RE: Hudson River PCBs Superfund Site: Baseline Modeling Report Peer Review

Critical Issues Imbedded in Fate and Transport Model Peer Review Charge Question 11

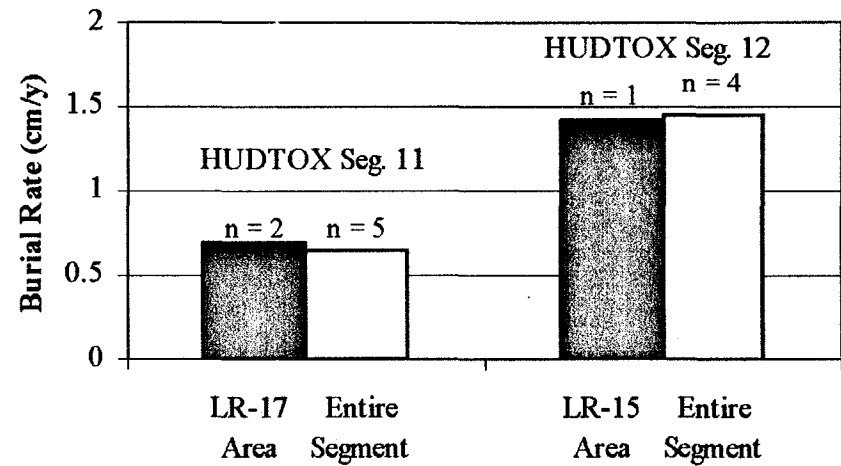
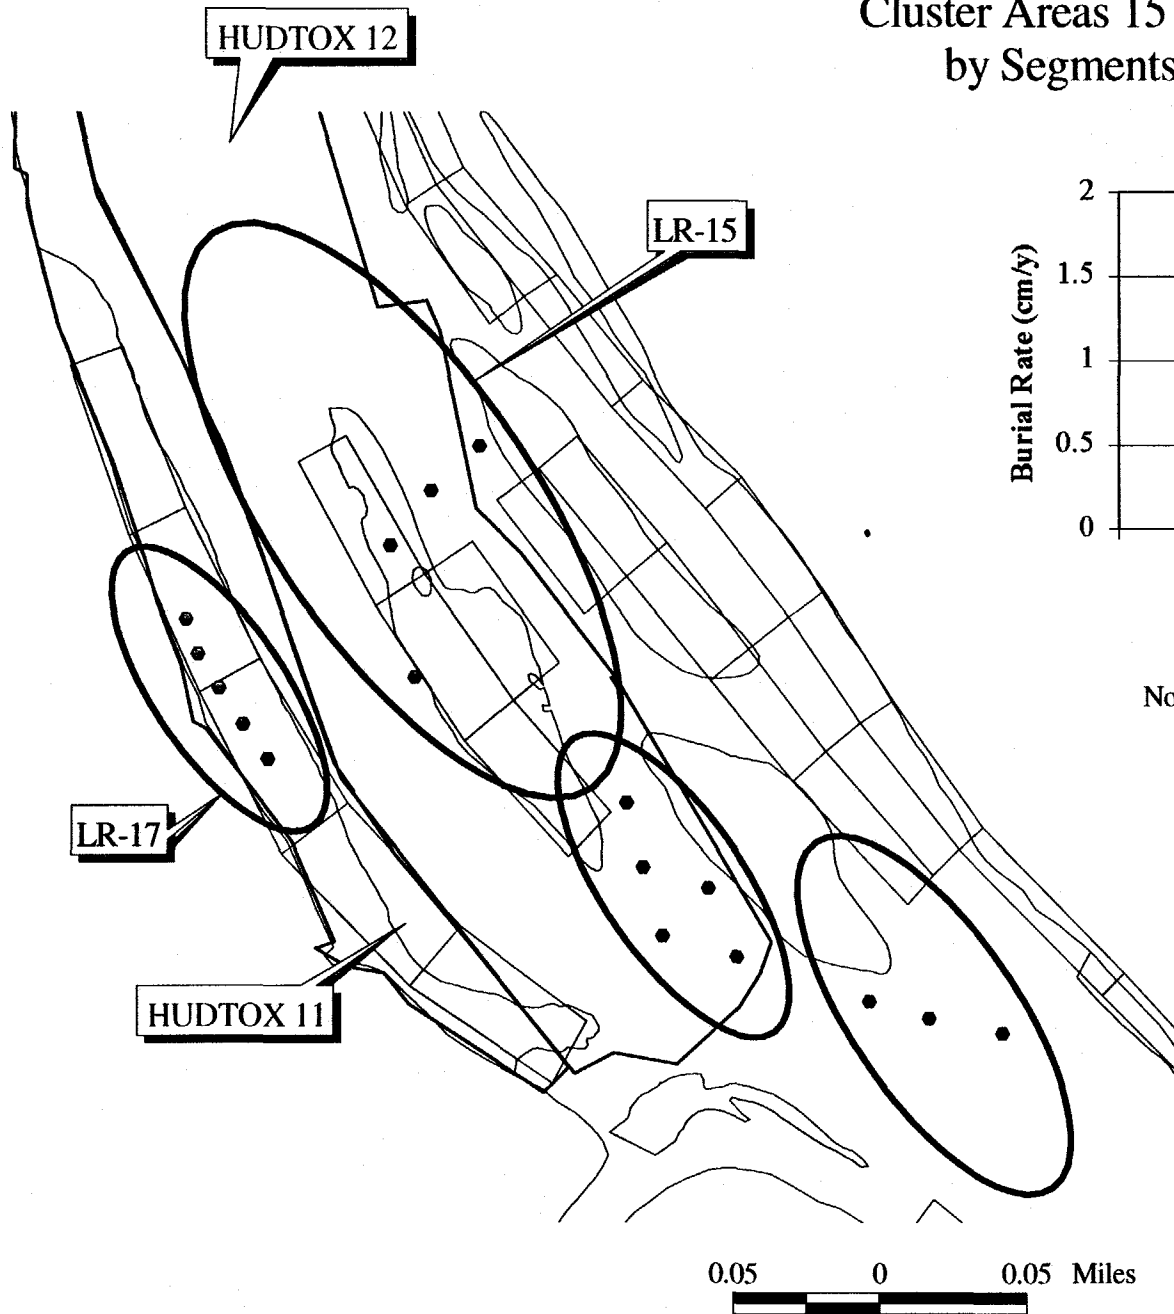
An obvious question is why did the LRCR conclude that PCBs in the most highly contaminated areas are not being buried if the modeling and the data cited above are at variance with such a conclusion? The answer lies in the flawed methodology of the LRCR analysis (GE, 1998). The analysis relies on comparisons between sediment PCB data collected in 1984 and 1994. Unfortunately, the comparisons are not valid because the 1984 samples chosen for the comparison were not randomly picked from all the data lying within designated areas, but were chosen because they had among the highest PCB levels in the data set. Further, the ability to see statistically meaningful differences between the 1984 and 1994 samplings was severely impaired because of the extreme variability among samples and the relatively small sample size. Finally, the statistical analysis of the data did not account for all of the sources of variance and may have underestimated the uncertainty of the estimated mass change¹. The reported uncertainty is already so large (4 to 59 percent) that the analysis has little power to determine what has occurred to the PCB inventory between 1984 and 1994.

¹ USEPA could have obtained an appropriate confidence interval for the year-to-year change by conducting an analysis of variance using a two-way classification by cluster and by year.

Given the weakness inherent in the statistical data comparison approach and the methodology errors, the LRCR conclusions are too unreliable to be used to understand PCB fate within the sediments of the TIP. The best overall tool to use is the mechanistically-based models that reconcile all the data available for each media.

Comparison of GE model computed cohesive sediment burial rates in Low Resolution Coring Analysis Cluster Areas 15 and 17 and in the larger areas represented by Segments 11 and 12 of the EPA Hudtox Model

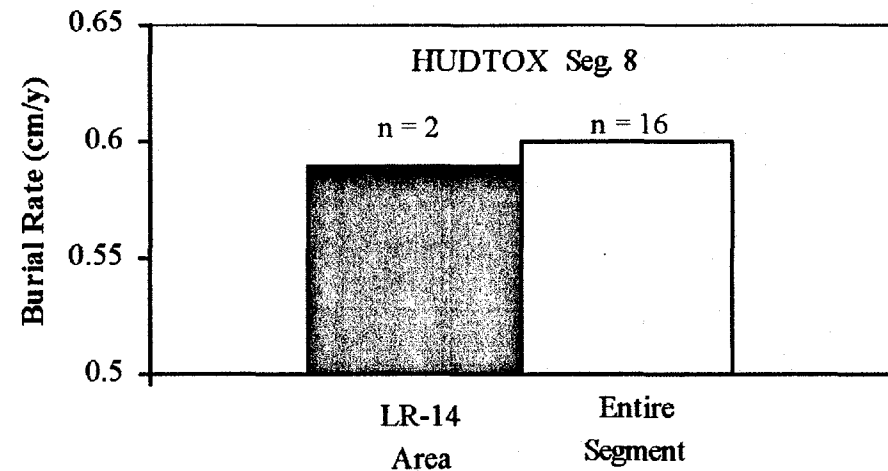
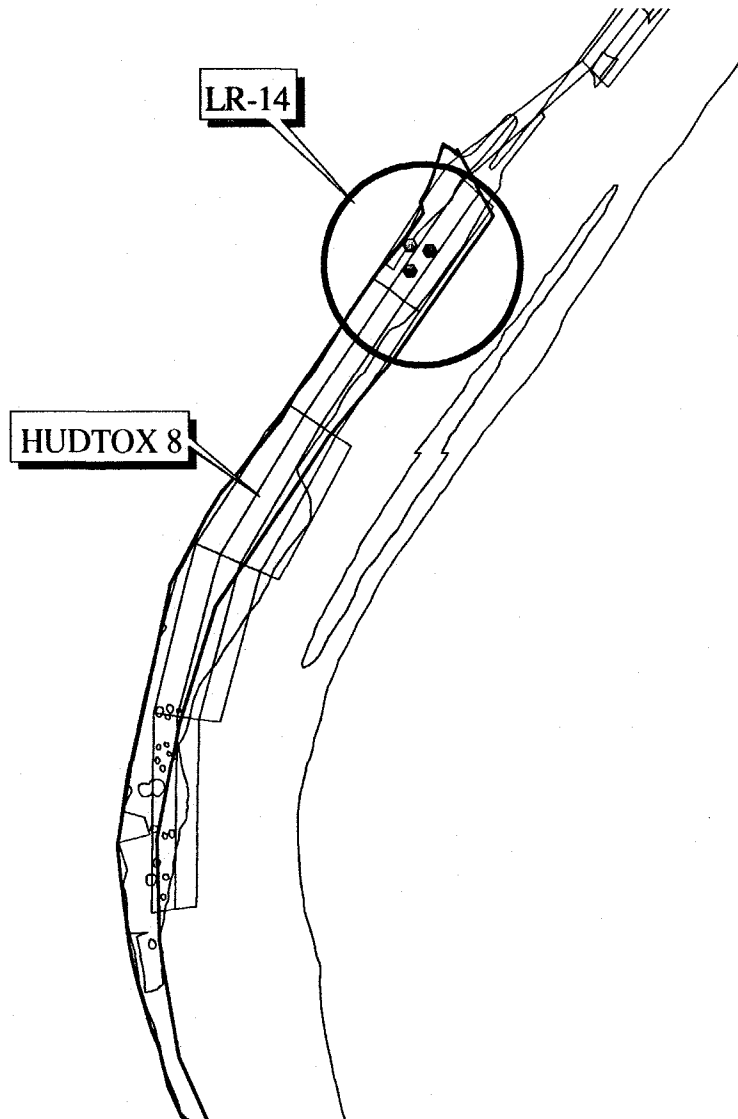
EPA has made no attempt to determine whether such deviation exists. Such a determination can be made using the EPA hydrodynamic and sediment erosion model, which has spatial resolution comparable to, or finer than, that of the geochemical analysis (see Figures 3-2 and 3-3 of the RBMR; USEPA, 2000). The General Electric hydrodynamic and sediment transport model, whose results were used by EPA in calibrating its model, also has sufficient resolution to examine conditions on the scale of the geochemical analysis. As shown for each of the 1994 sampling clusters on which the geochemical analysis relies (see attached figures), the GE model indicates that the targeted locations are **not** erosional and tend to have greater deposition rates than the averages for the larger areas represented by the HUDTOX model.
